Greenfield School Administration Office Project

Mechanical Addendum #1

May 6, 2016

Re: Addendum No. 2 (Includes Mechanical Addendum No.1 attachment)

MITSUBISHI VRF MULTIZONE HEAT PUMPS
Indoor Units
Greenfield School Administration Office Project - Greenfield, MA
Revised per Addendum #1
05/06/16

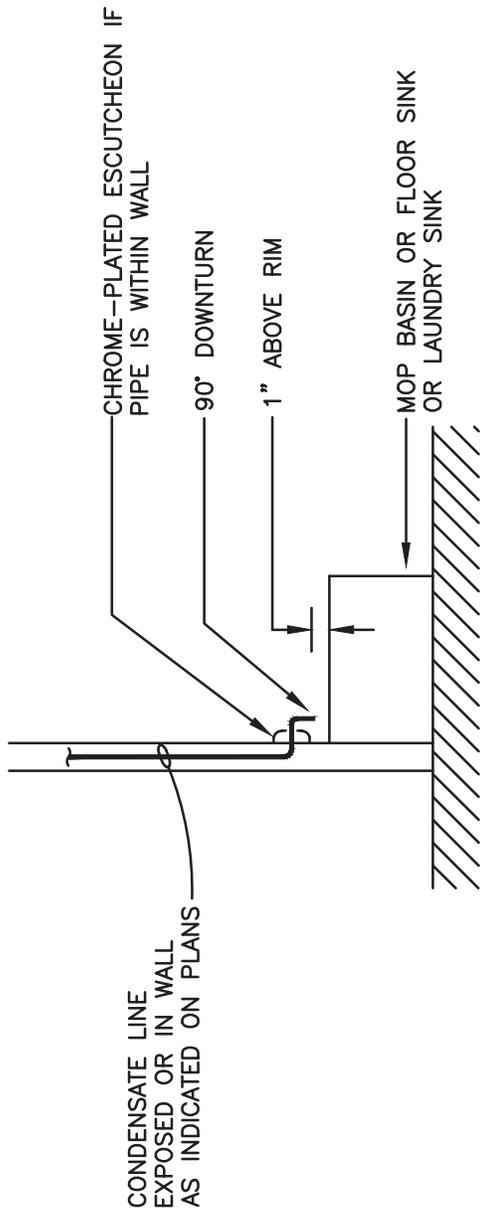
- 231675-S3. For HP-1, delete “SNOW/HAIL GUARDS KIT”.
- 231675-S4. See attached revised indoor VRF heat pump unit schedule.

CONDENSATE PIPING TO GRADE DETAIL

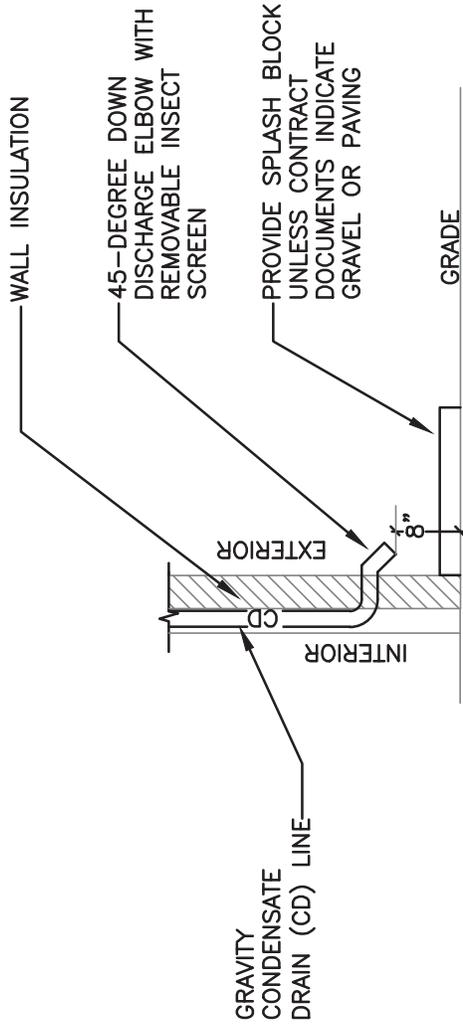
- M1.1 At Note M on the plan, the CD pipe extends outside to grade. See attached Detail 435-08.
- M1.1 “Diffuser and Register Size Table” should be called “Supply Diffuser Size Table”.

CEILING DIFFUSER DUCTWORK OPTIONS

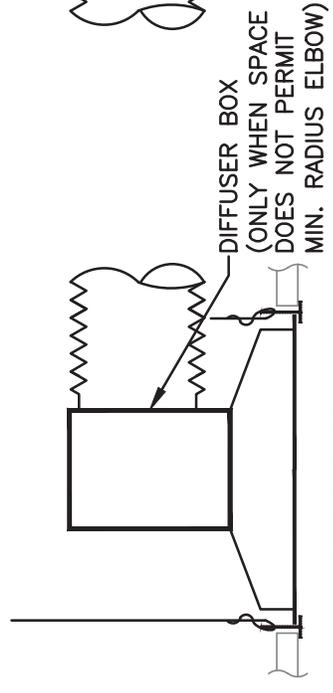
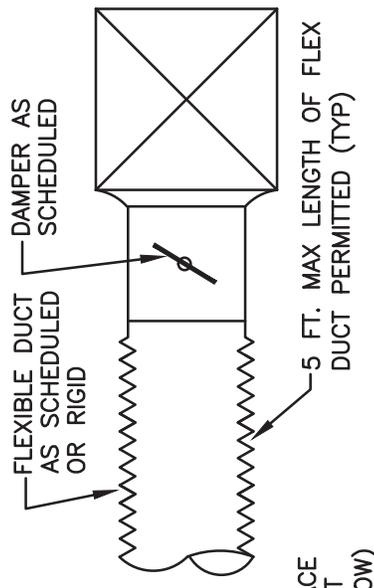
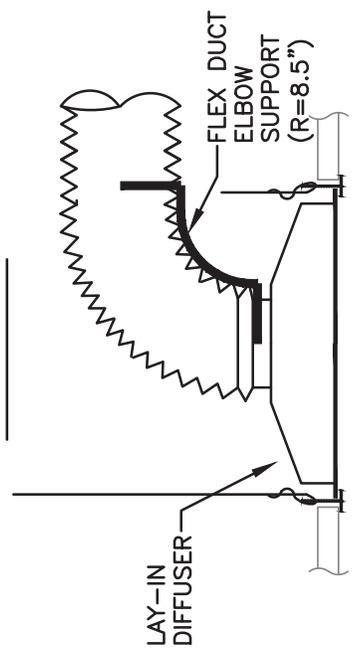
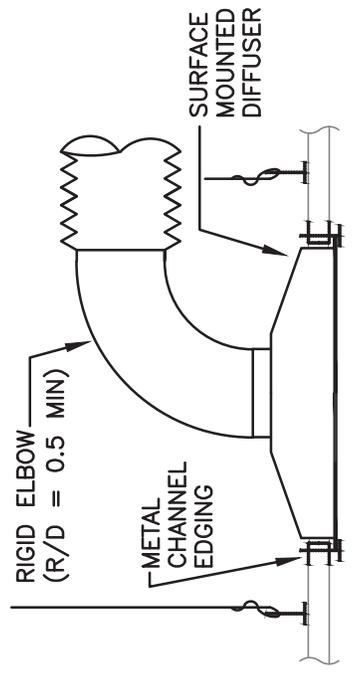
- M1.2 Delete Detail 891-04.
- M1.2 Add attached Detail 435-01.
- M1.2 Add attached Detail 891-13.
